PROJECT BORN FRAGRANCE - shop fit-out

TITLE **SETTING-OUT PLAN**

REV 00 - preliminary

PRELIMINARY - NOT FOR CONSTRUCTION

SHEET **SD-01**

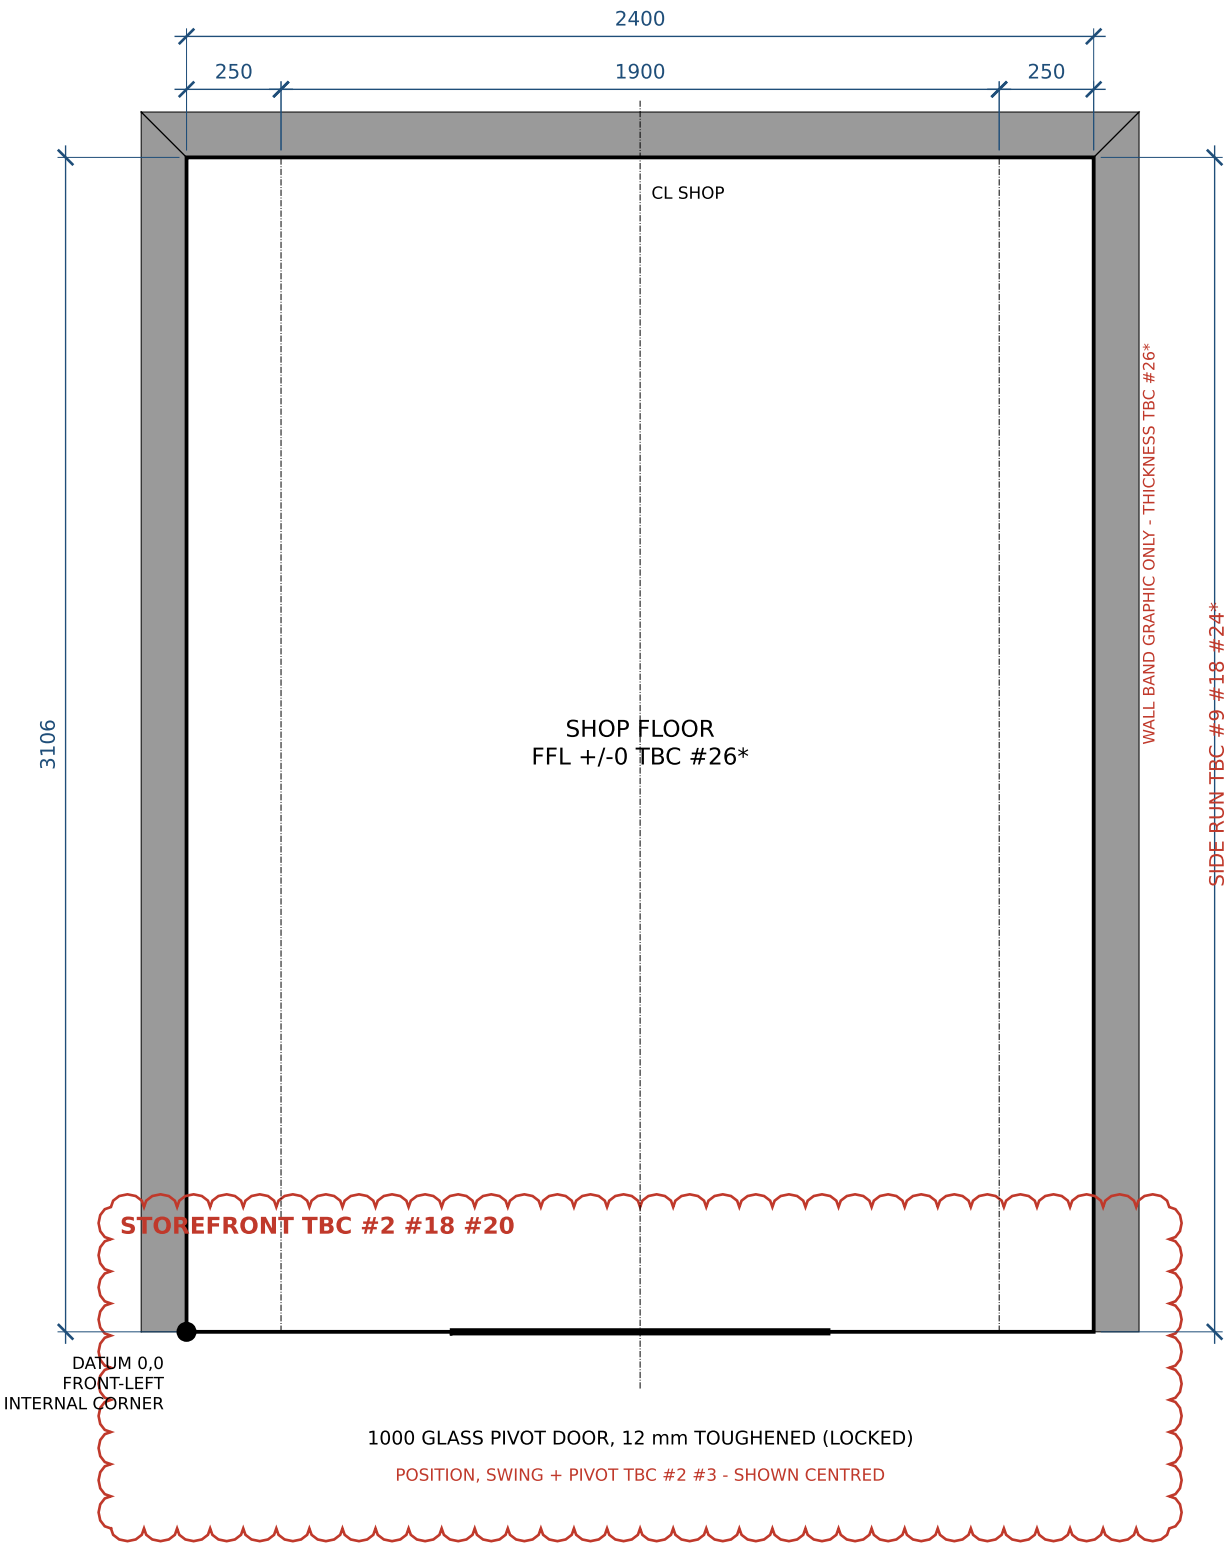
Ceiling +2600 above FFL (locked).
Clear aisle 1900 = 2400 - 2 x 250 (derived).
Is 2400 x 3106 finished size? TBC #4.

- #2 Display column width, door opening width, fixed glass
- #3 Door swing direction and pivot offset
- #4 Is 2400 x 3106 the finished size (after plaster)?
- #18 Storefront display column depth, and shelf facing (street, shop or both)
- #20 Entrance threshold / step and any floor level change
- #23* North direction
- #26* Vertical datum (FFL) and wall thickness / construction
- #16 Fixings, MEP, fire and escape requirements

SHEET **SD-02**

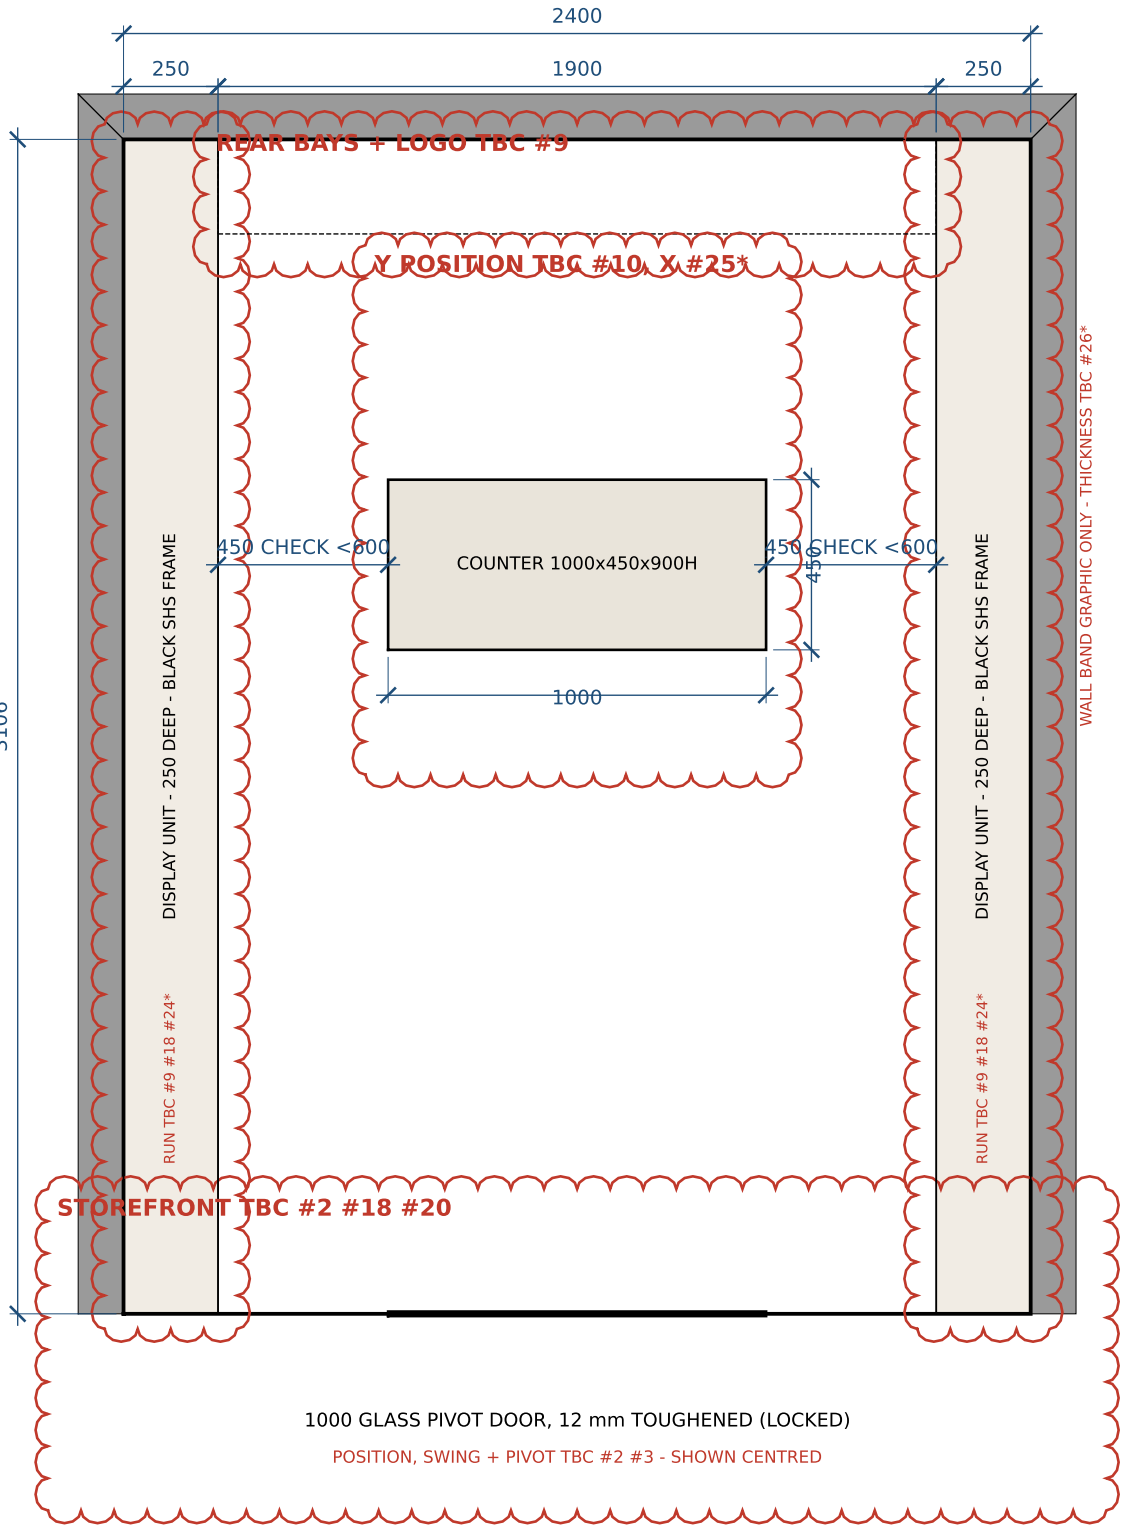
Counter centred x 700-1700 is a PROPOSAL.
Side clearance 450 < 600: CHECK staff access.
Exclusions: no timber, brass, plants, products.

BAYS ~600, COUNT TBC #24*
BASE CAB TBC #7

- #7 Base cabinet height and door type
- #9 Rear wall bay width, shelf count, logo size and height
- #10 Counter distance from rear wall and staff clearance
- #13 Floor-level LED strip (visible in render): keep or omit
- #18 Storefront display column depth, and shelf facing (street, shop or both)
- #24* Side bay count, widths and upright spacing
- #25* Counter lateral position (centring is a proposal)
- #4 Is 2400 x 3106 the finished size (after plaster)?

SHEET **SD-03**

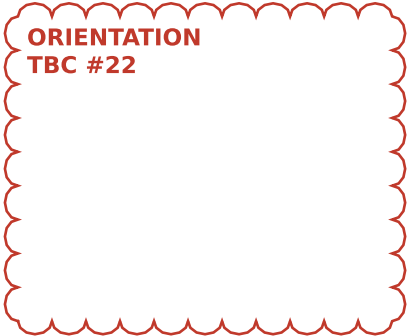
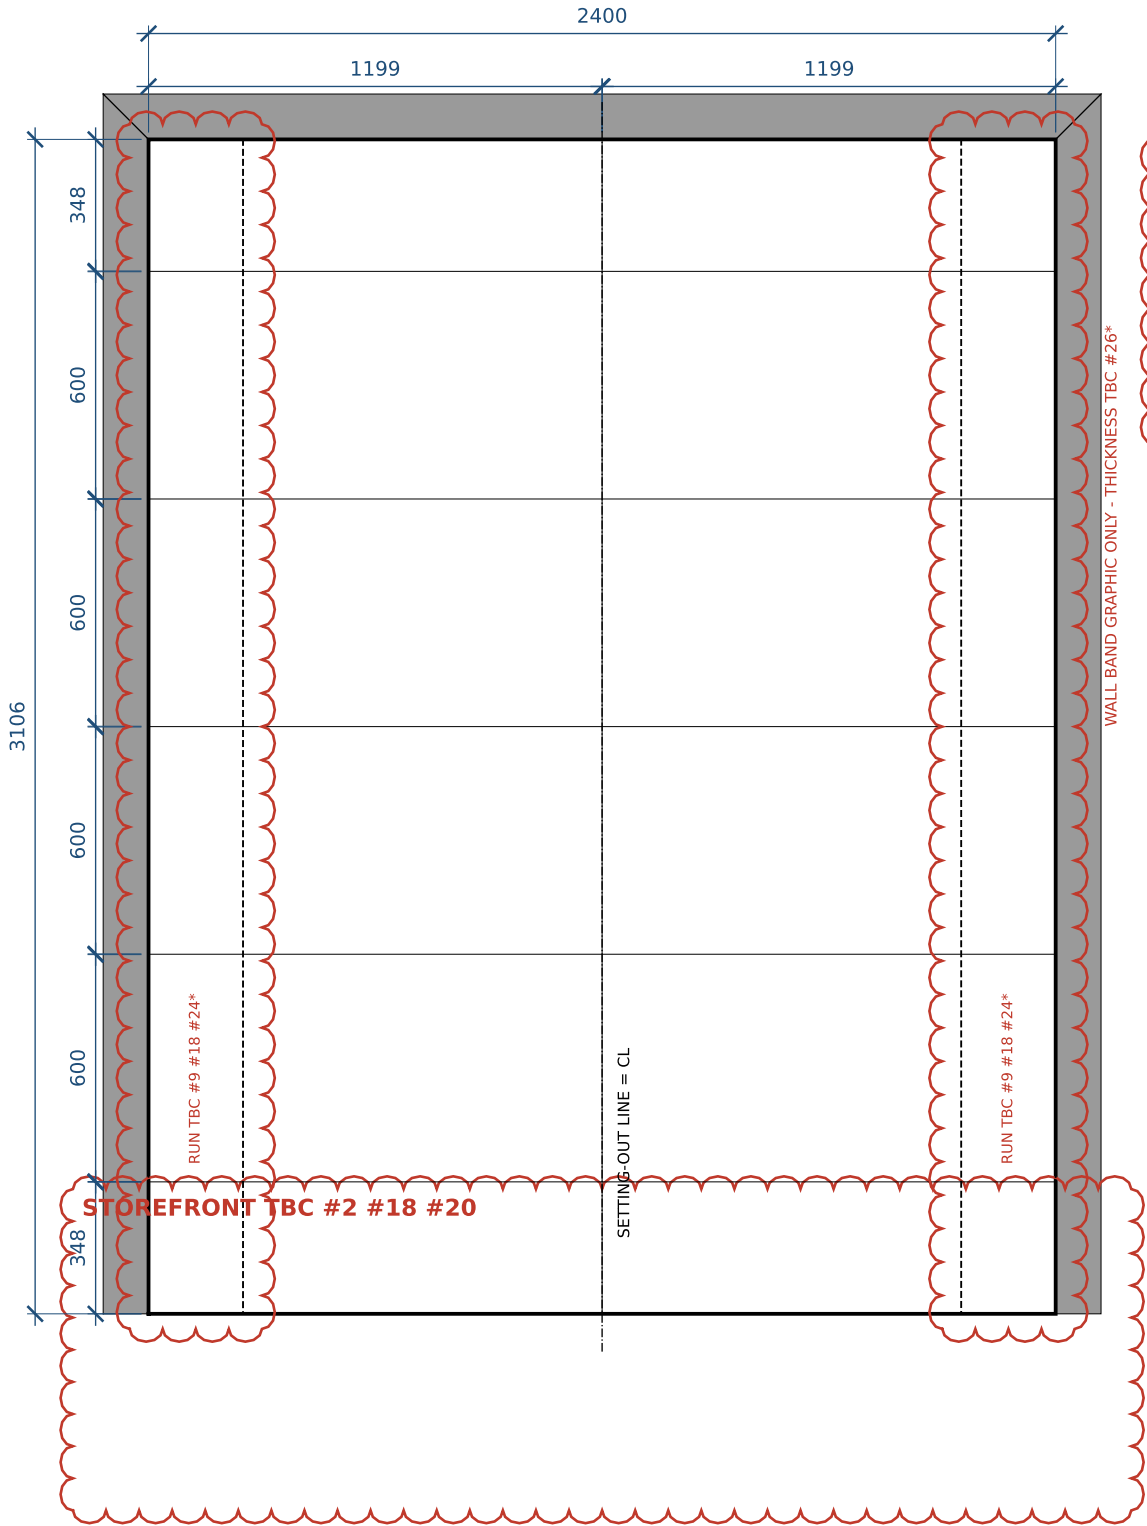
2 mm grout. Joints between tiles only;
perimeter/movement joint TBC #26*.

Owner to choose A or B (TBC #22).
Threshold / level change TBC #20.

TILE UNDER
UNITS TBC #14

- #22 Floor tile orientation (1200 across or along), and cut sizes allowing for 2 mm grout (2 x 1200 + joint = 2402 > 2400; depth cuts approx 348, not 353)
- #14 Floor tile extent under display units
- #20 Entrance threshold / step and any floor level change
- #4 Is 2400 x 3106 the finished size (after plaster)?
- #26* Vertical datum (FFL) and wall thickness / construction

SHEET **SD-04**

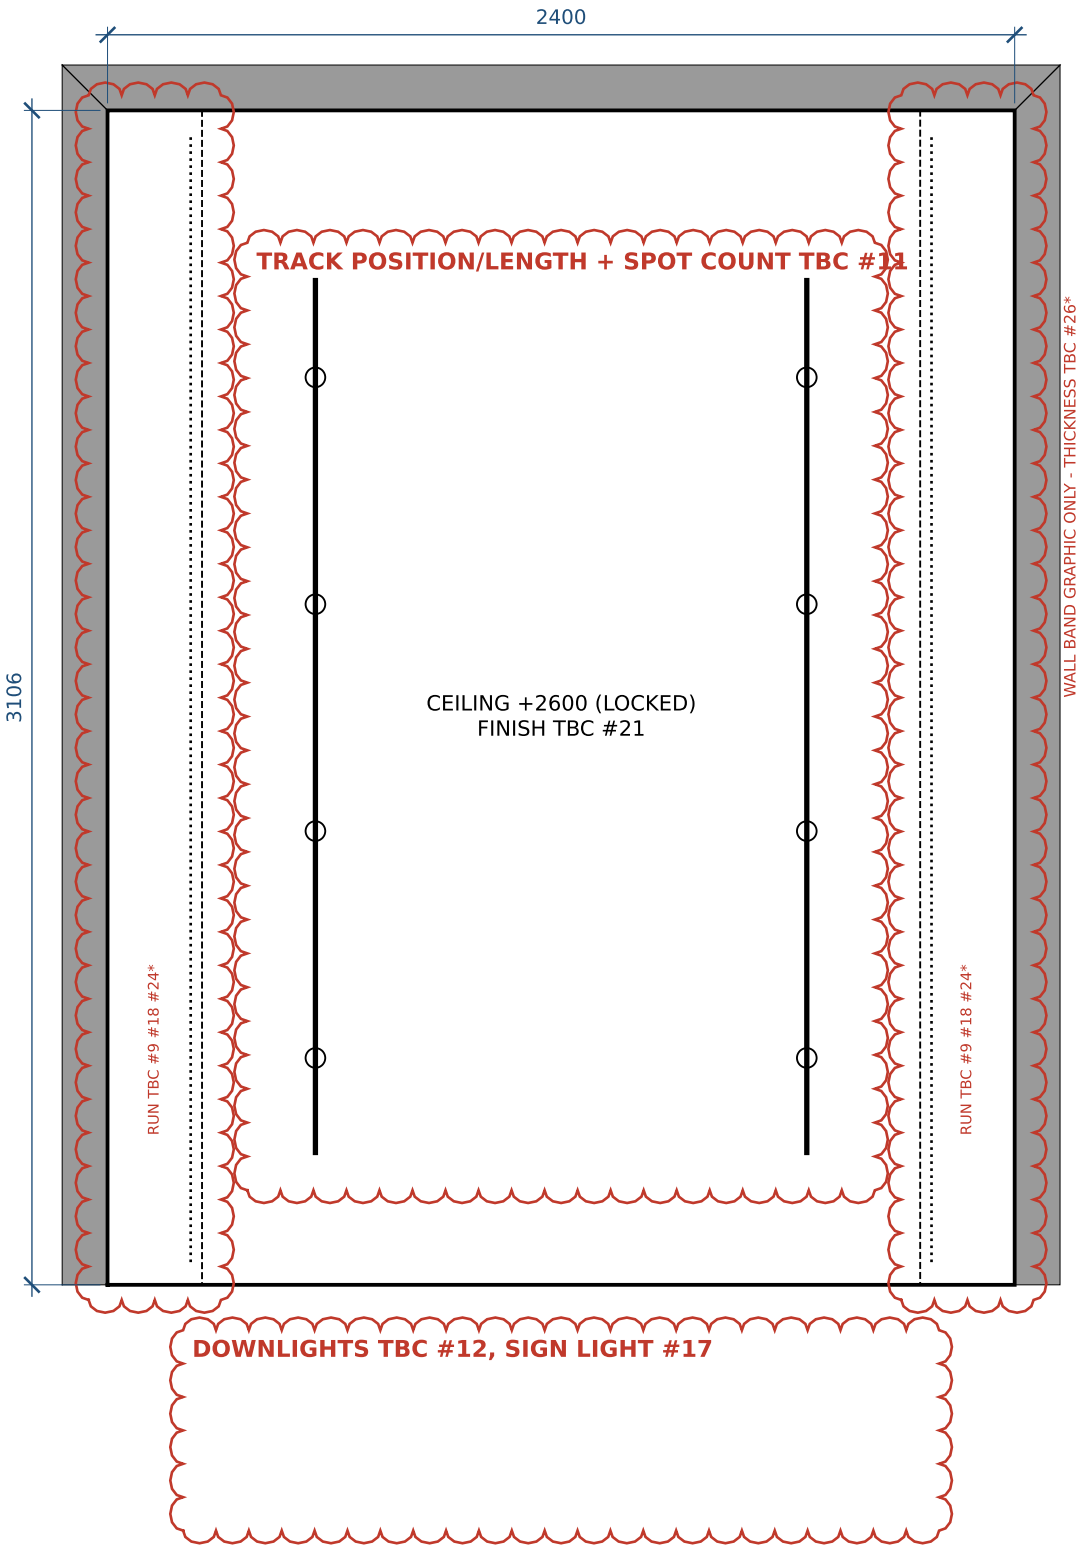
No pendants or decorative ceiling features.
Positions shown are diagrammatic only.
Floor-level LED strip TBC #13.

- #11 Track positions and lengths, spotlight count
- #12 Recessed downlights (visible in render): keep or omit
- #13 Floor-level LED strip (visible in render): keep or omit
- #17 Exterior sign illumination: halo-lit (spec) vs front-lit by downlights (render)
- #21 Ceiling finish
- #4 Is 2400 x 3106 the finished size (after plaster)?

SHEET **SD-05**

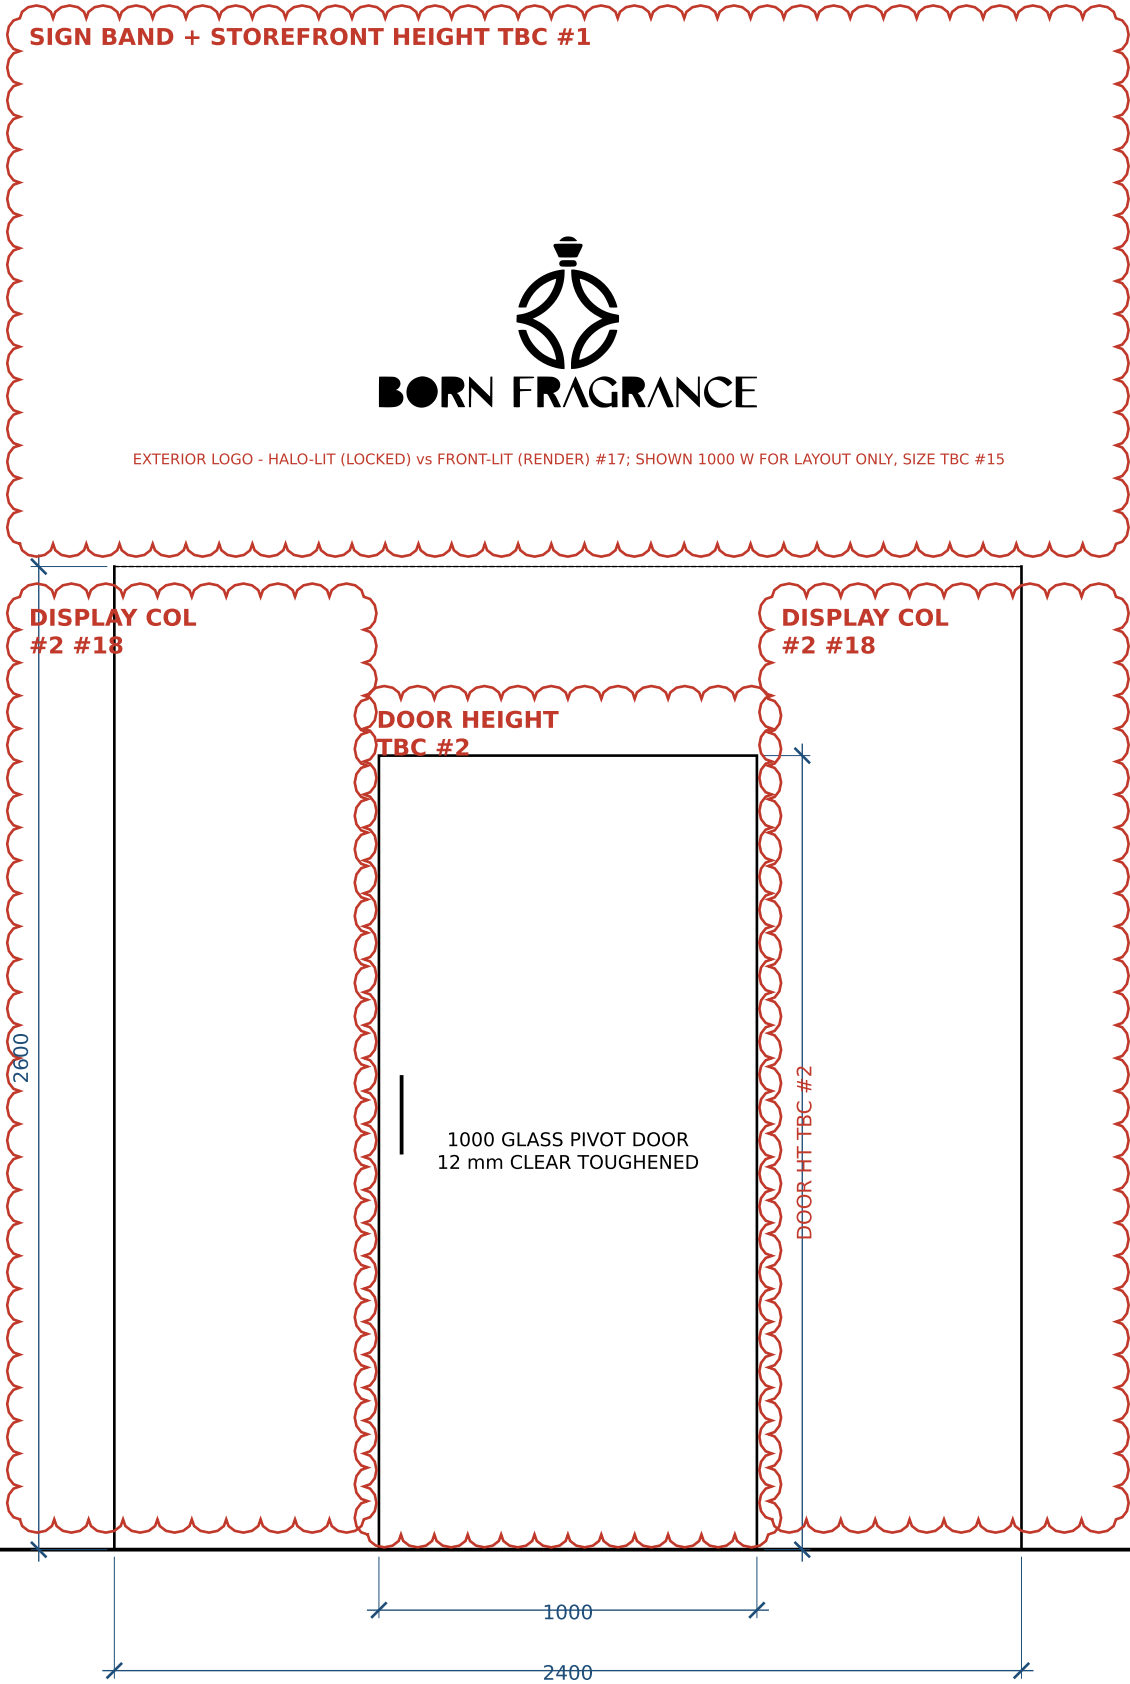
MESH PANELS + DISPLAY COLUMNS PER RENDER INTENT; ALL SIZES TBC

- #1 Storefront overall height and sign band height
- #2 Display column width, door opening width, fixed glass
- #3 Door swing direction and pivot offset
- #12 Recessed downlights (visible in render): keep or omit
- #15 Exterior and interior sign sizes
- #17 Exterior sign illumination: halo-lit (spec) vs front-lit by downlights (render)
- #18 Storefront display column depth, and shelf facing (street, shop or both)
- #20 Entrance threshold / step and any floor level change
